PLANS AND DOCUMENTS referred to in the PDA DEVELOPMENT APPROVAL

Approval no: DEV2016/759
Date: 25 January 2017

AMENDED IN RED

527 GREGORY TCE

LEVEL 01

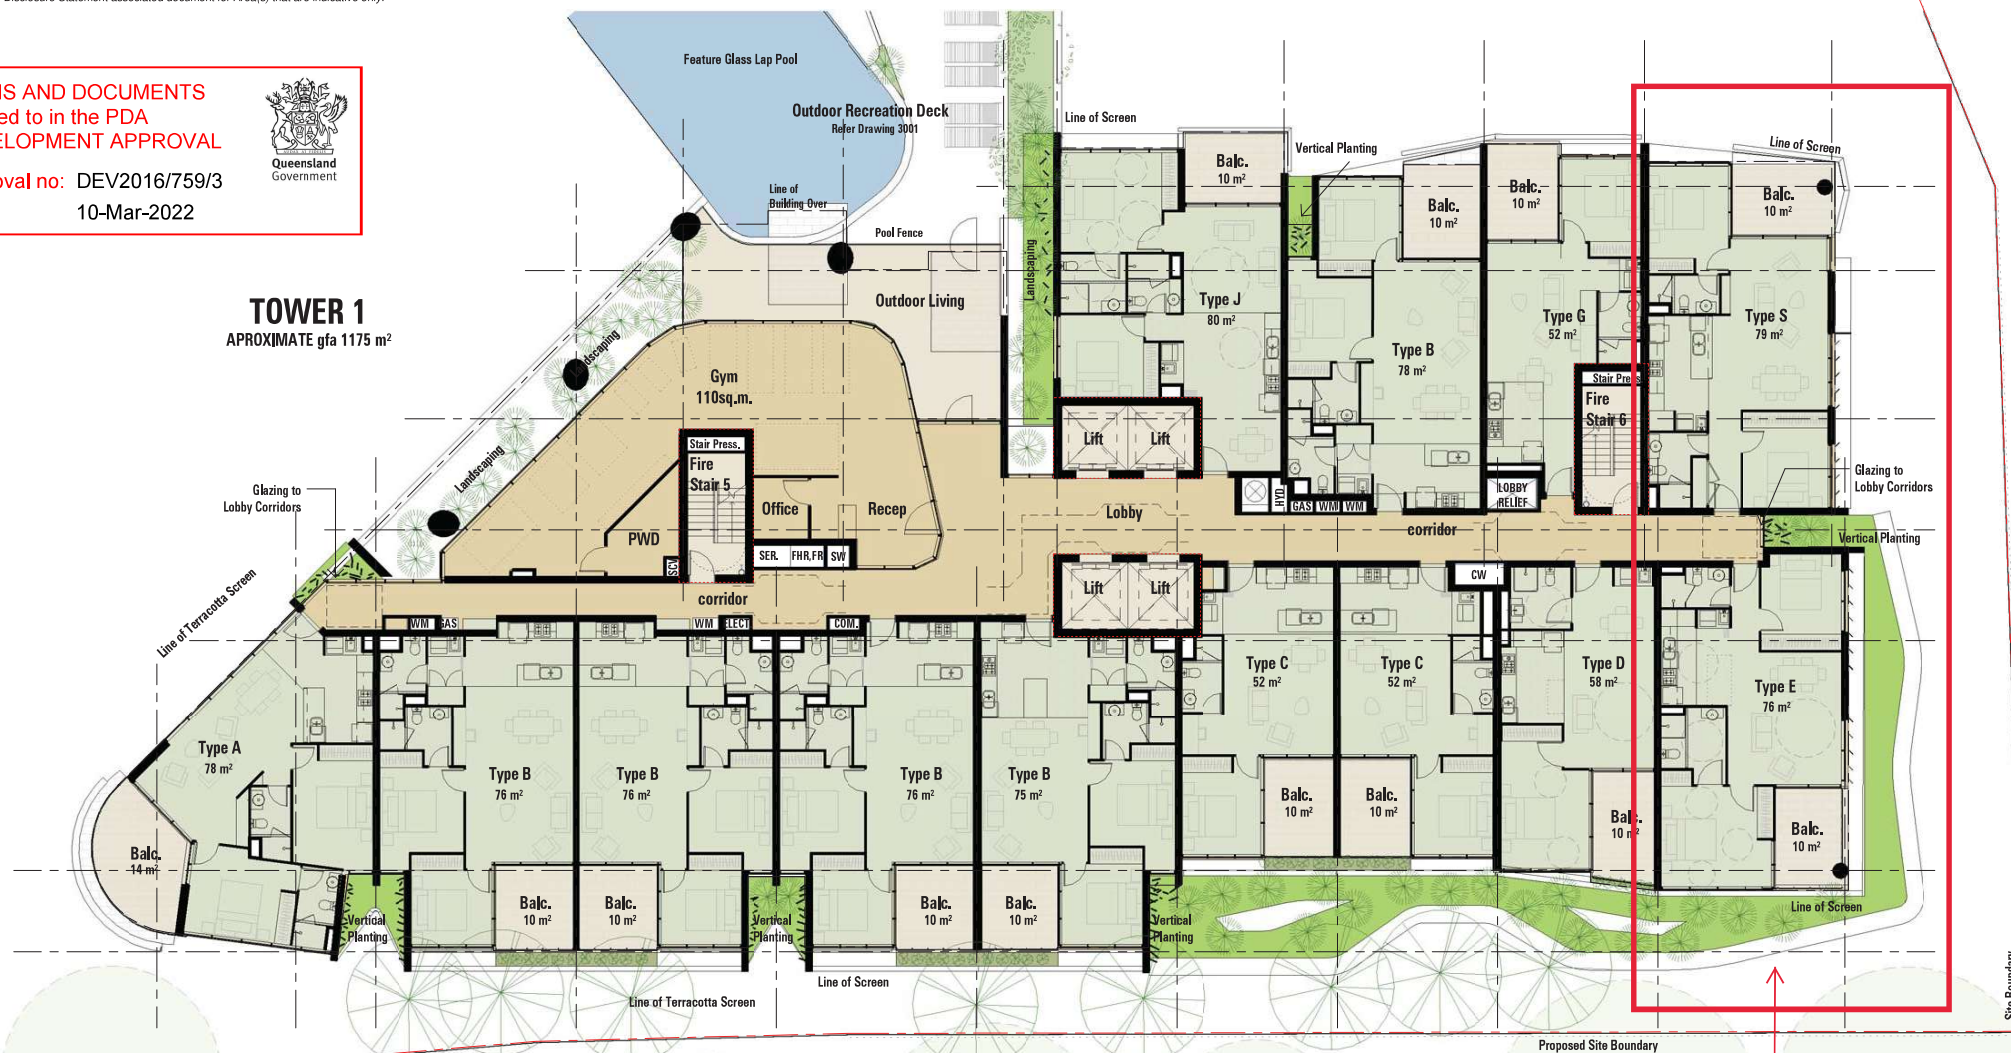
Reconfigure outlook of habitable spaces of all apartments on the eastern boundary towards Gregory Tce and the Drill Hall (e.g. through the use of a fin-shaped floor plate, providing solid walls to the north-east, with large windows looking north and south).

Increase building setback to 9m from boundary.
Reconfigure apartments / building design to achieve setback.

INCREASED DEPTH TO PLANTER BED. VERTICAL TRELLACE SYSTEM TO BE INSTALLED ALONG BLADE WALL

INCREASED DEPTH TO PLANTER BED. VERTICAL TRELLACE SYSTEM TO BE INSTALLED ALONG BLADE WALL

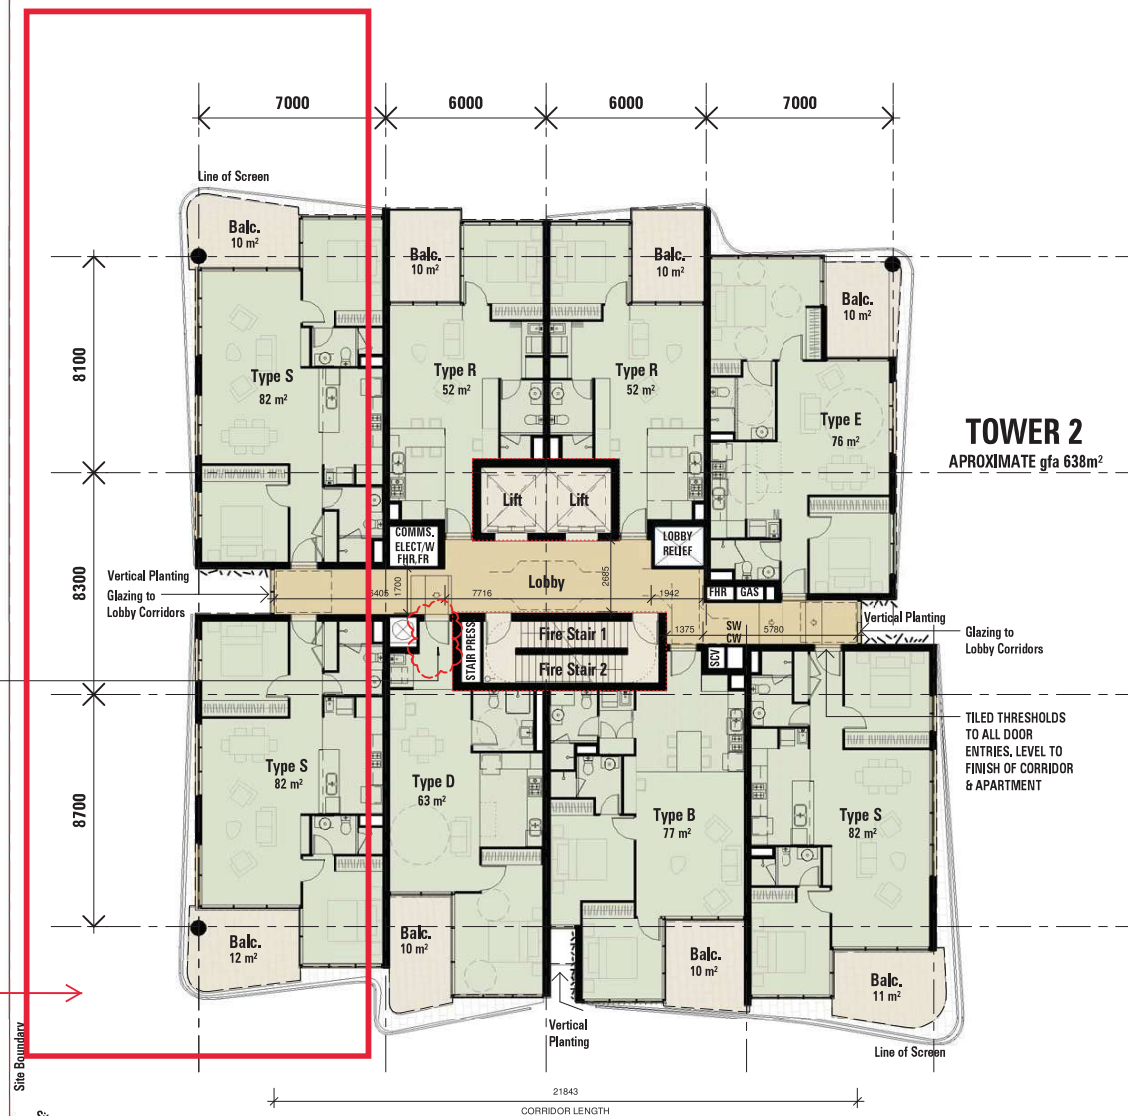
Reconfigure outlook of habitable spaces of all apartments on the eastern boundary towards Gregory Tce and the Drill Hall (e.g. through the use of a fin-shaped floor plate, providing solid walls to the north-east, with large windows looking north and south).

APARTMENT DOOR ALIGNED WITH CORRIDOR TO COMPLY WITH ACCESS STANDARDS
*AREA INCREASE FROM 82 TO 63m²
*ALL ENTRY DOORS ACCESSIBILITY COMPLIMENT FROM CORRIDOR

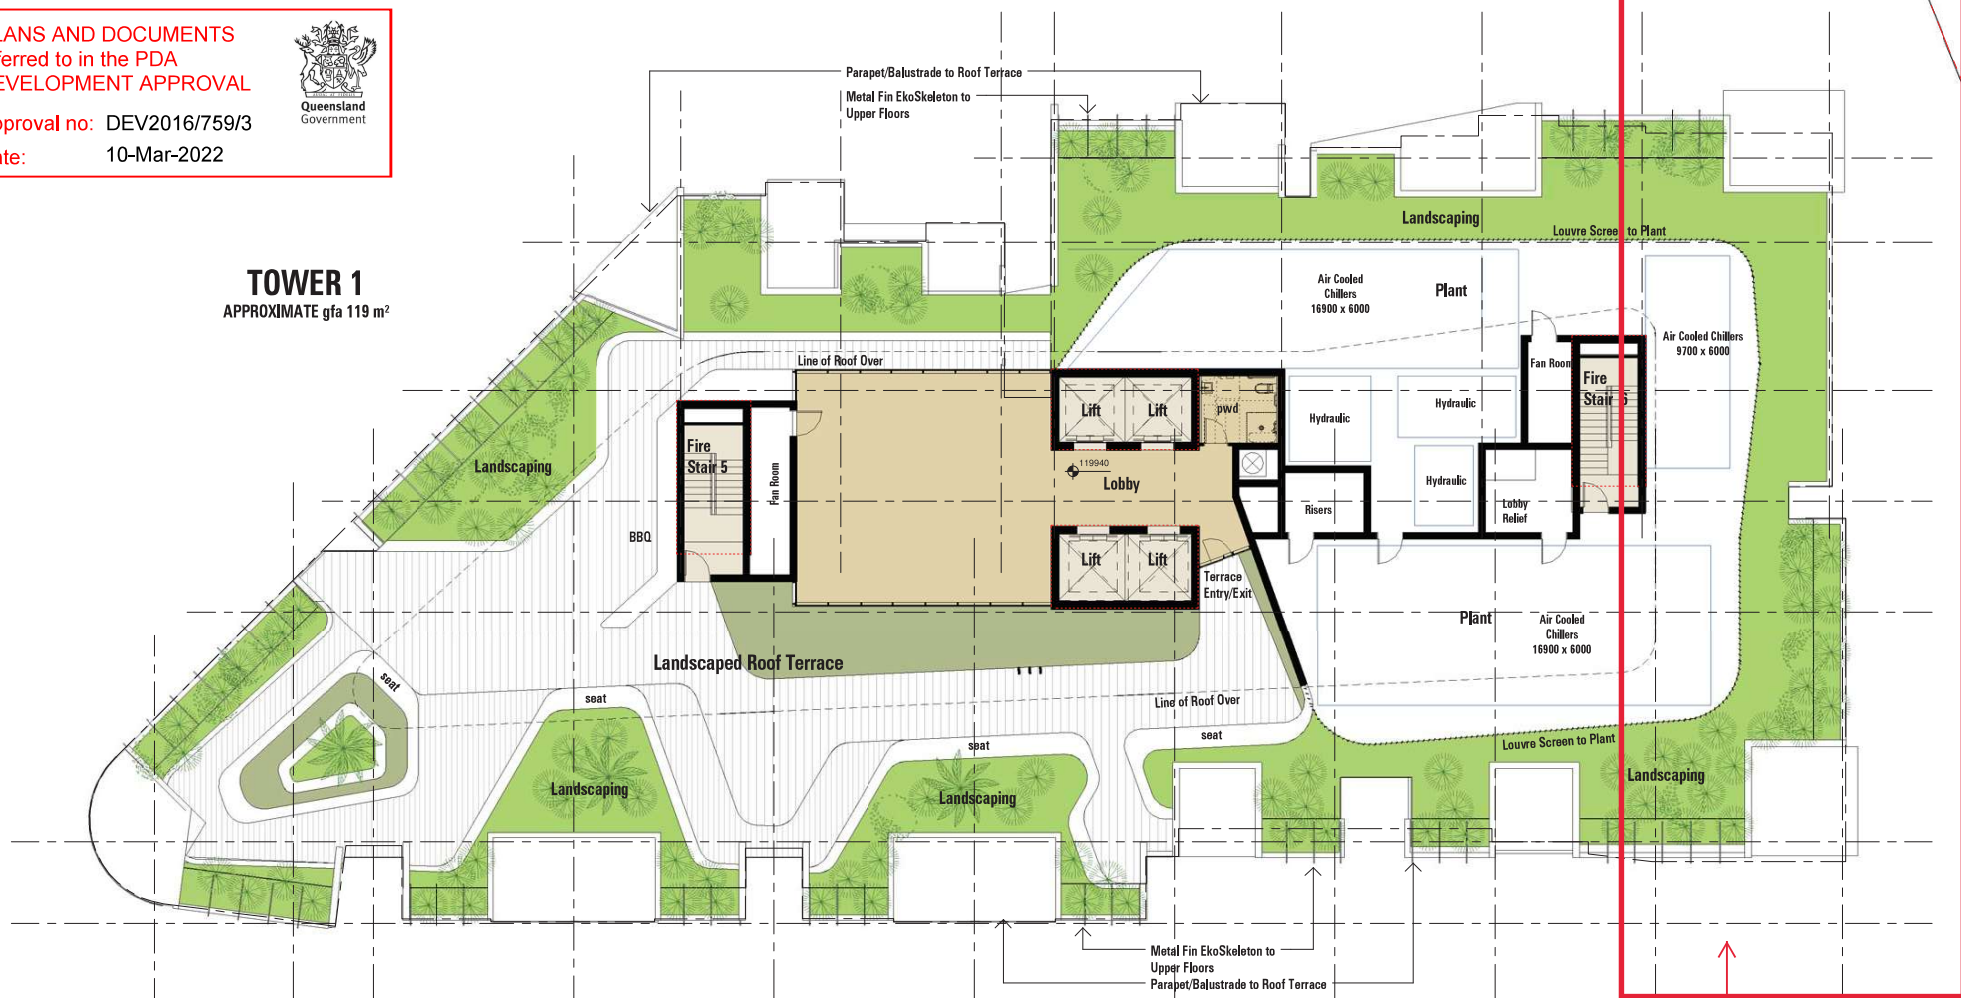
Amend rooftop as per changes to lower floors, as required.

Amend rooftop as per changes to lower floors, as required

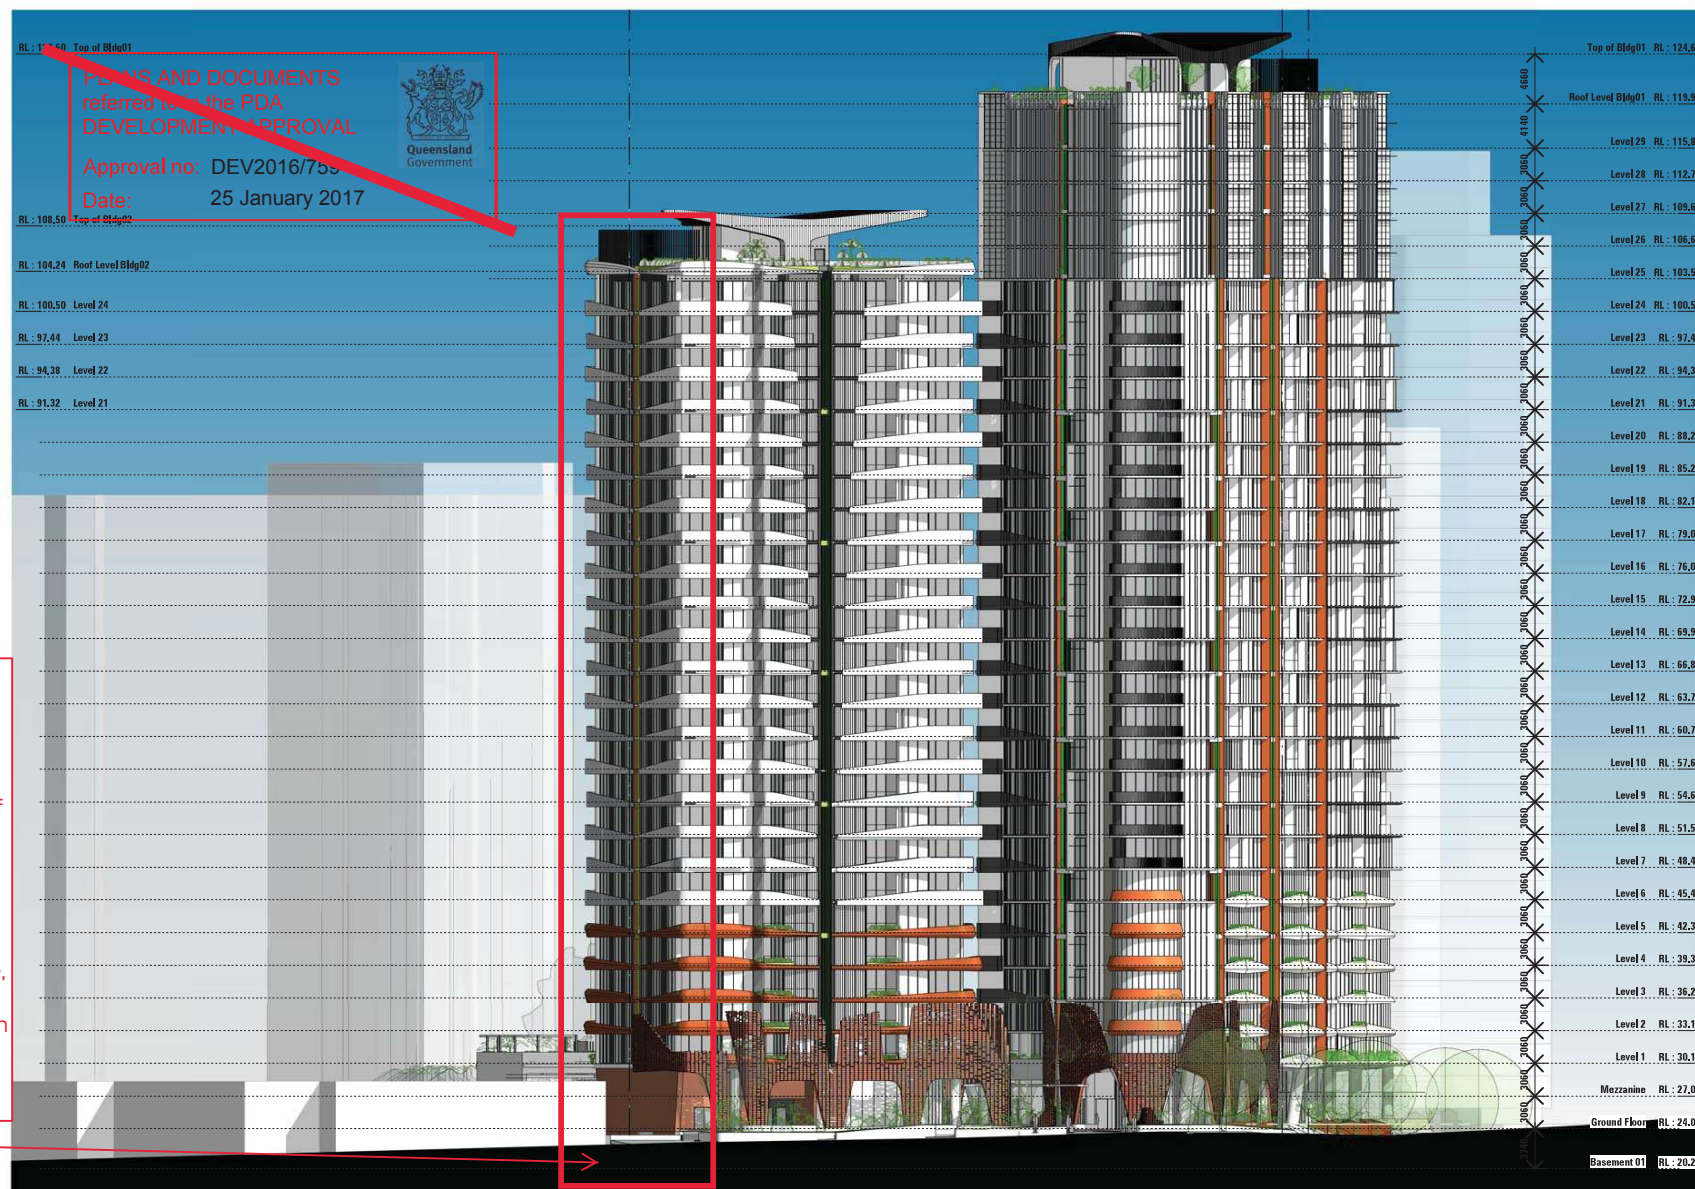
Increase building
setback to 9m from
boundary.
Reconfigure
apartments /
building design to
achieve setback.

Reconfigure outlook
of habitable spaces of
all apartments on the
eastern boundary
towards Gregory Tce
and the Drill Hall (e.g.
through the use of a
fin-shaped floor plate,
providing solid walls
to the north-east, with
large windows
looking north and
south).

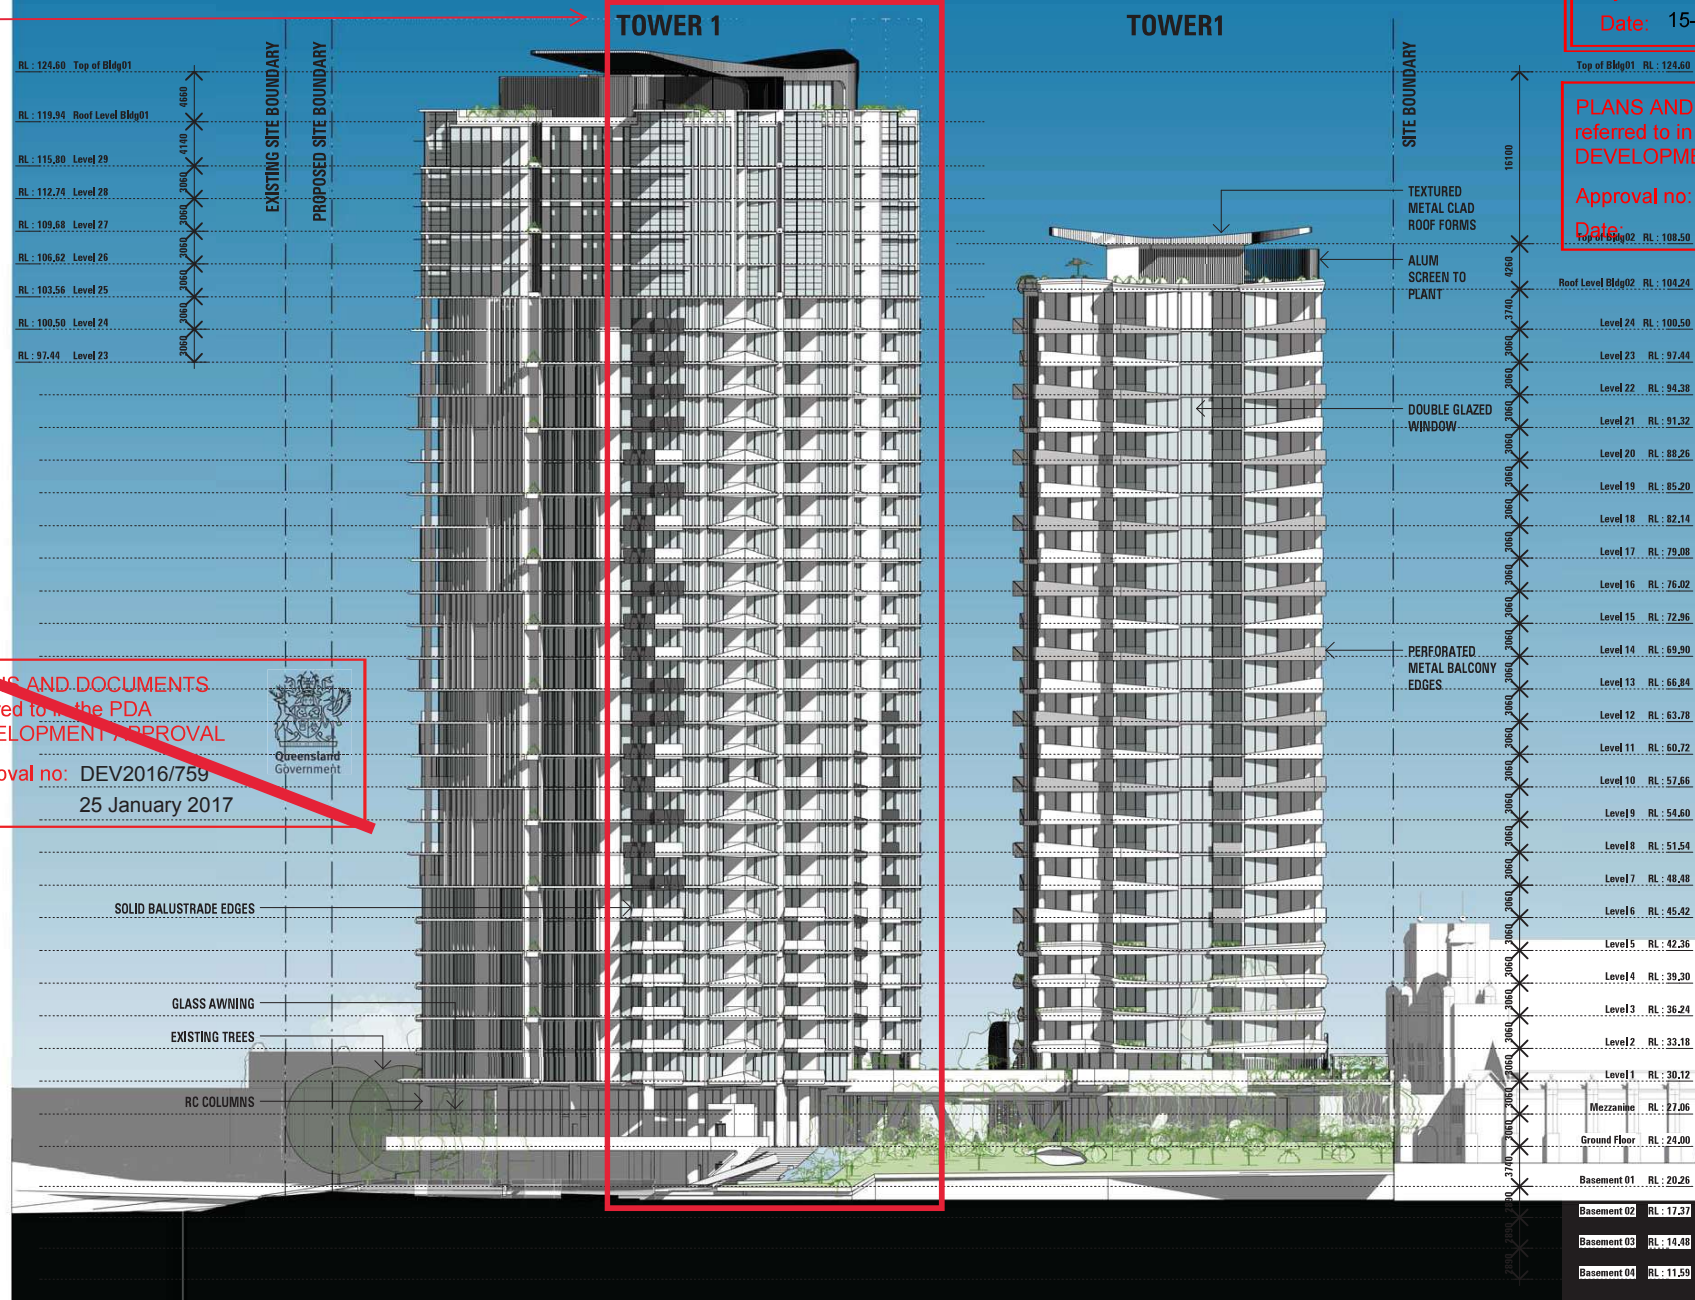
Increase building
setback to 9m from
boundary.
Reconfigure
apartments /
building design to
achieve setback.
